NOTICE OF DECISION

CLASS 3 SITE PLAN REVIEW / CLASS 2 ADJUSTMENT CASE NO.: SPR-ADJ24-31

APPLICATION NO.: 24-114744-PLN

REQUEST: A consolidated application for a Class 3 Site Plan Review for development of a new building and expansion of an existing general manufacturing, retail sales, and eating and drinking establishment use (Don Froylan Creamery) with two Class 2 Adjustments requests to:

SITE PLAN

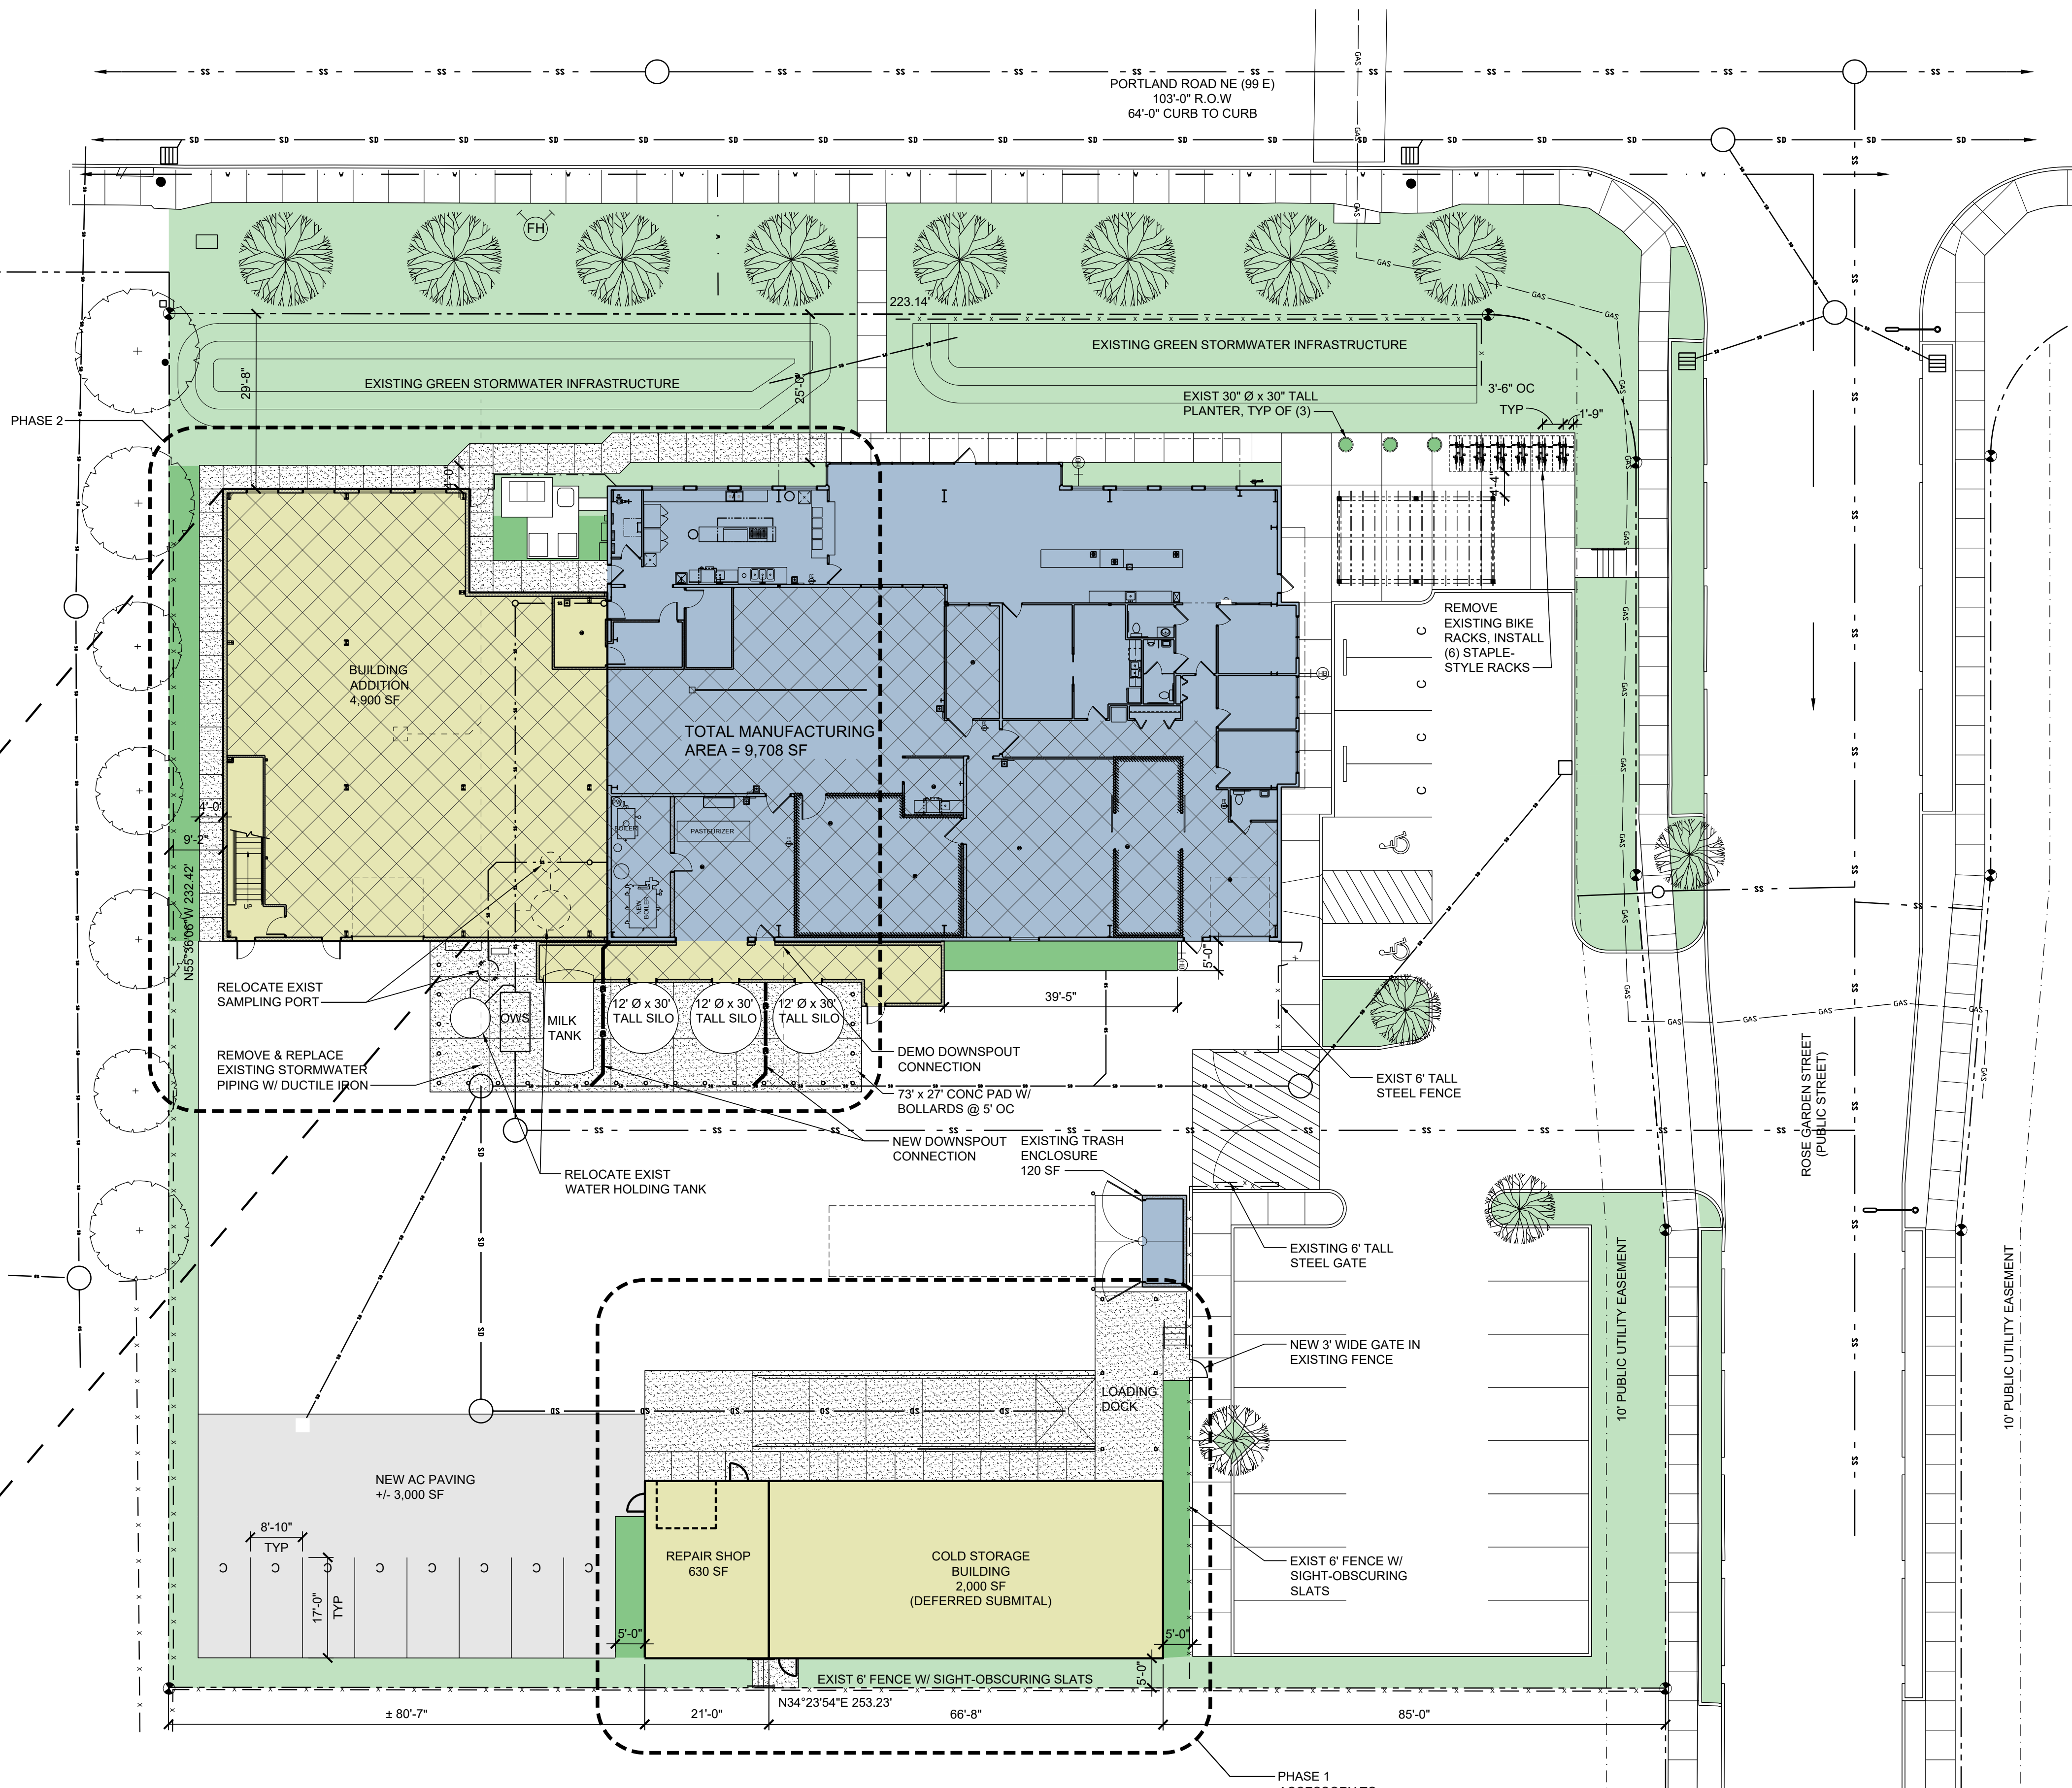
Finding: The proposed pedestrian connection from the primary building to Portland Road NE and Rose Garden Street NE is an existing paved and raised connection. The proposed new connection from the existing network to the accessory building is raised and paved; however, a portion of the connection crosses the vehicle use area. The portion that crosses the vehicle use area does not provide a visually differentiated material, elevation, or other physical method for that portion. As such, the following is conditioned.

Finding: The applicant's plans do not demonstrate conformance with the required lighting for the pedestrian paths, therefore the following condition applies:

Finding: As shown on the development plans, the new off-street parking area provides through-access from aisle leading to Rose Garden Street NE, allowing vehicles to enter and exit the street in a forward motion with no backing or maneuvering within the street. The proposal meets the standard.

Finding: The development plans indicate 12 short-term bicycle parking spaces located within 50 feet from the primary entrance. The standard is met.

Finding: As shown on the site plan, each bicycle parking area has direct access to a primary building entrance and the public right-of-way, free of obstruction or barriers, in conformance with the requirements of SRC 806.060(b).

Condition 1: At the time of building permit, the plans shall be modified to meet SRC 800.065(b)(1)(B) where the required pedestrian connection for the accessory building crosses a vehicle use area.

Condition 2: At the time of building permit, the applicant shall provide lighting along the existing and proposed pedestrian pathway.
